DETENTION BASIN STAGE-STORAGE TABLE BUILDER

Project: Clear View Industrial Park, Filing 2A

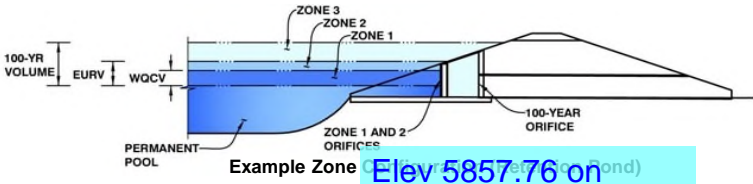
This is not the SDI Worksheet. This worksheet needs to be included in the drainage report (to include the outlet structure design)

Elev 5857.76 on plans.

Revise and use the override stage/area column to input the actual pond volume. Include the corresponding elevation in the first column. Spot check: Area for 100yr WSE 5860 does not match the construction plans (7,153 sf)

Spot check from Construction Plans: MP=5857.76, 100yr WSE= 5860.1, Difference=2.34

Update both the construction plans and MHFD-Detention worksheet so data corresponds with each other.
